## **Addendum NO. 2**

PROJECT: Phase 1 Part B  
Wright Ave Jail  
Date: July 31, 2025

PHASE 1 PART B FOR:  
**TWIN FALLS COUNTY - WRIGHT AVE JAIL**  
2815 Wright Ave, Twin Falls, ID 83301  
**MAIN FLOOR SECURITY PLAN - AREA 'A'**

**E1B-3.0A**

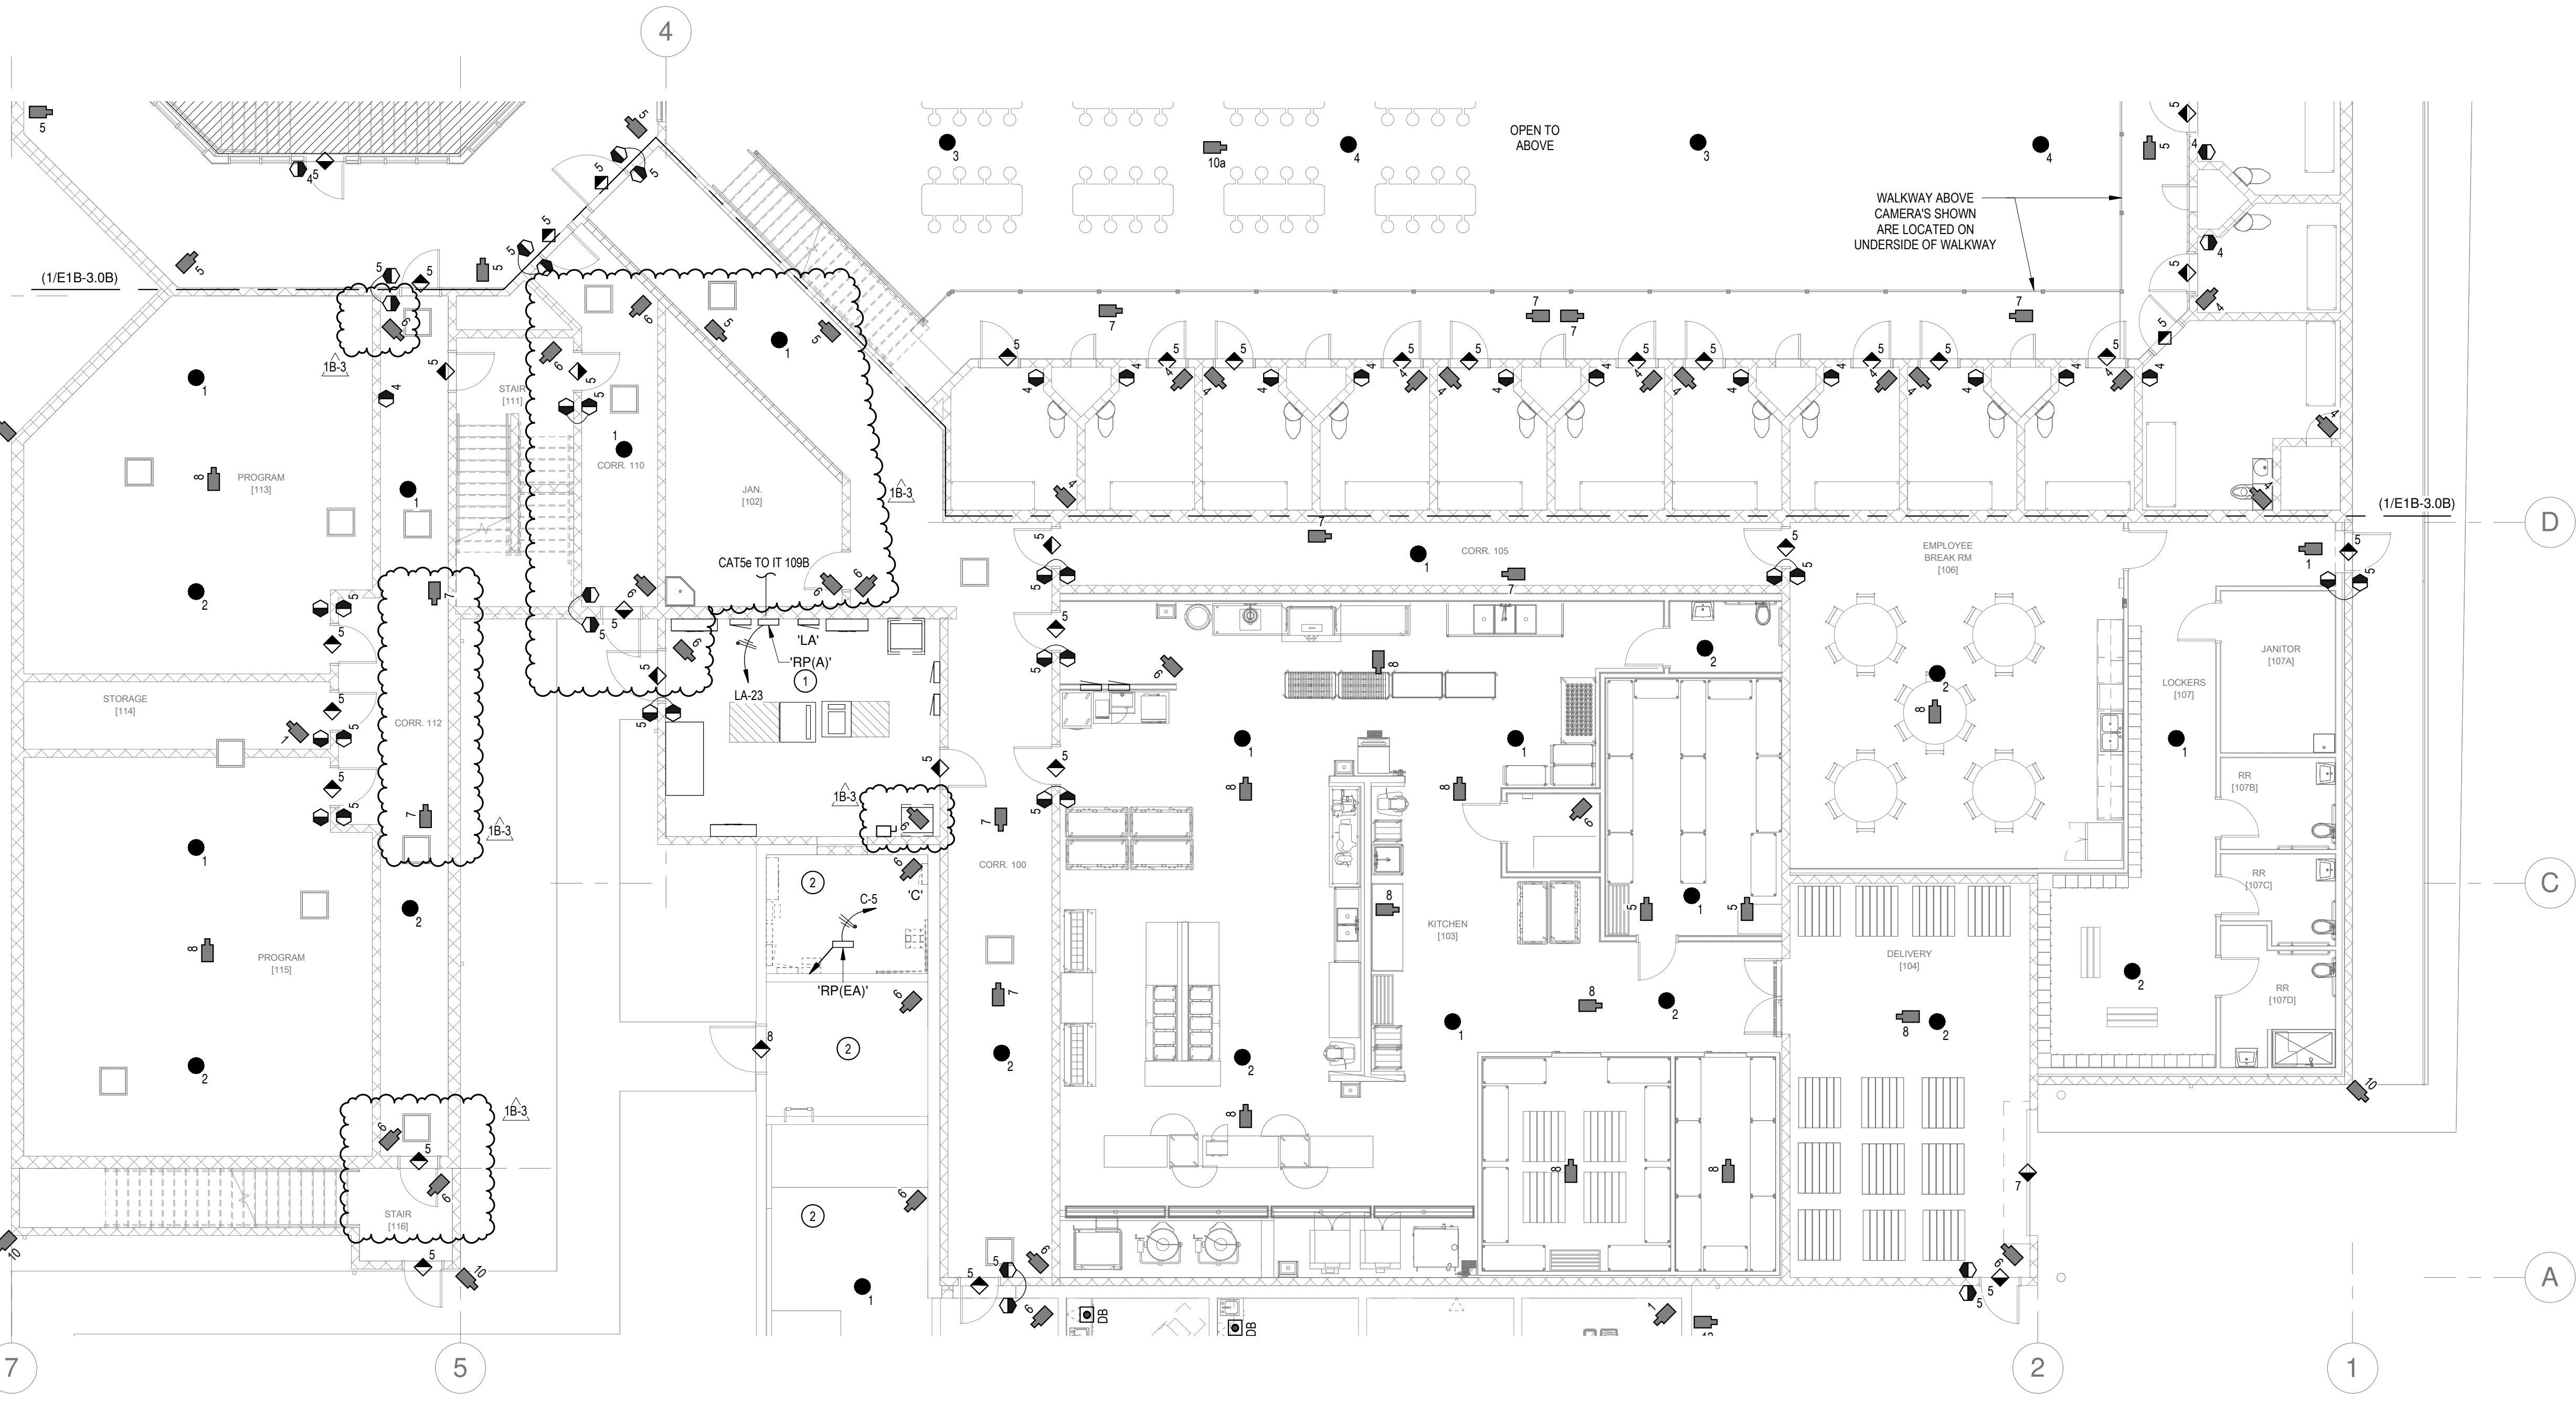
1. Grenade ports shall be fabricated by TRC Fabrication LLC in Idaho Falls, Idaho 208 542-9600
2. There were several cameras that did not show up on the redesign drawing, refer to the updated sheet (E1B-3.O) for these camera locations.

REVISE Sheet E1B-3.0
